Author response to reviewer comments

Anonymous Reviewer #1

This work uses emission factors from ~20 published studies across ~9 regions to estimate national methane emissions from active mid- and up-stream oil/gas production facilities for 2021. Using infrastructure inventories (Enverus, OGIM database), regional emission rates were modelled and validated with airborne surveys.

- Revised Figure 2 added:

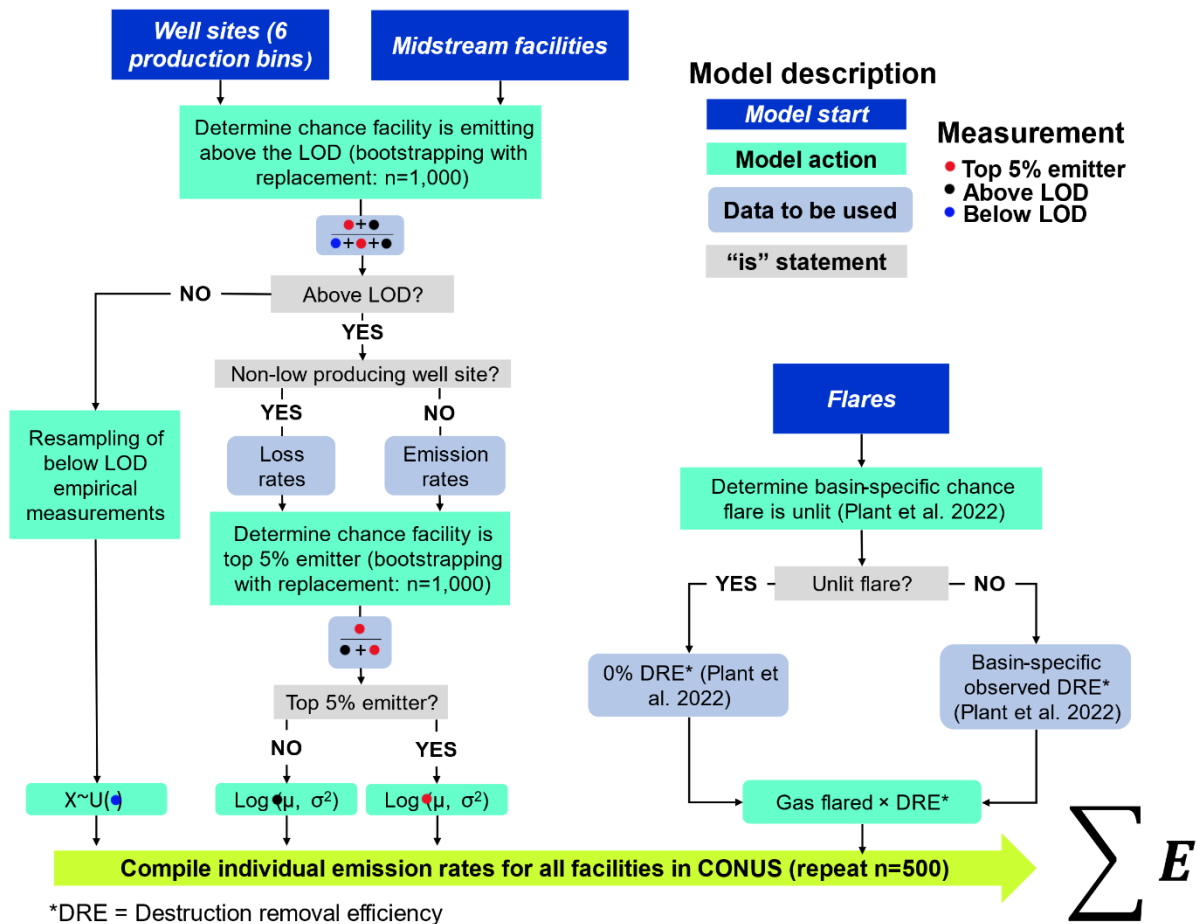
I have two main hesitations that together question the novelty of this work and the contributions that it provides. First, the chosen methodology, which is complicated and I am not convinced contributes to the authors results, discussion, or conclusions (see general comment 1). Second, the close similarity of this work prior work from this group (see Omara et al. 2022; 2024) questions the novelty of this manuscript. Specifically, the aggregation of emission factors is already published in Omara et al. 2018, 2022, & 2024. Scaling from emission factors to national budgets using Enverus is repeated from Omara et al. 2022 & 2024. Lastly, comparison of national/regional/basin-level emissions to airborne studies was previously done in Omara et al. 2022 & 2024.

For the second comment mentioned by the reviewer regarding the methods in this work sharing similarities with previous studies (e.g. Omara et al. 2018,2022,2024), each of these previous studies had a different scope and presented different data outputs than our work. Our work differs from these previous studies by Omara et al. by i) estimating full methane emission distribution curves (i.e., not just total methane emissions) across multiple spatial scales ranging from the entire CONUS to the aerial remote sensing campaign survey regions, ii) presenting both the cumulative, and grouped, emission distribution curves for major oil/gas emitting facility categories, which allows for the clear distinction between emission distribution curves from different facility categories and a relative assessment of their total contributions to CONUS annual emissions, iii) presenting detailed comparisons to prior work (i.e., satellite and remote sensing studies) on the distribution of methane emissions across spatial scales and at different emission rate thresholds, which involved the additional analysis of data provided by other studies, and iv) a revised methodology that utilizes new ground-based facility-level measurement data and a separate approach for accounting for lit and unlit VIIRS flare detections. As we discuss in the Main Text, characterizing the full methane emissions distribution curves, that is, the contributions from individual facilities emitting below or above an emission rate threshold is crucially important for effective methane emissions mitigation. For example, any methane measurement platform with an established limit of detection and/or 90% probability of detection, could reference the emission distribution curves we present in our work, and determine a rough approximation of what percentage of total methane emissions their measurement method technique could capture. Our work represents the first comprehensive attempt to develop such an emissions distribution curve, using empirical measurements collected from ground-based measurement methods and robust probabilistic models to characterize the facility-level distributions for the full US upstream and midstream oil and gas methane sources. As part of this work, we estimate emissions from major upstream and midstream oil and gas methane sources, including well sites, natural gas gathering and transmission compressor stations, natural gas processing plants, and emissions from natural gas flaring facilities, accounting for methane emissions from both the lit and unlit flares.

- In order to improve the clarity of our methods, and to better illustrate differences between our methods/results and other studies, we have added the following text in the manuscript.
 - [page 6-7] ***We calculate annual methane emissions from all facility categories (i.e., six production bins of production well sites, T&S compressor stations, G&B compressor stations, and processing plants, and VIIRS flare detections) using a multi-step probabilistic modeling approach adapted from multiple studies (Omara et al., 2018, 2022; Plant et al., 2022) (Fig. 2). Briefly, for each individual facility and VIIRS flare detection in the CONUS for 2021, we***

- “Figure 2: Flowchart describing the facility-level estimates, with steps colored according to the specific process and data being used. We note that methane emission rates for flares are calculated using a separate approach from that of production well sites and midstream facilities. Processing plants and T&S compressors are excluded from the determination of whether a facility is a top 5% emitter due to a lack of available empirical measurement data.”
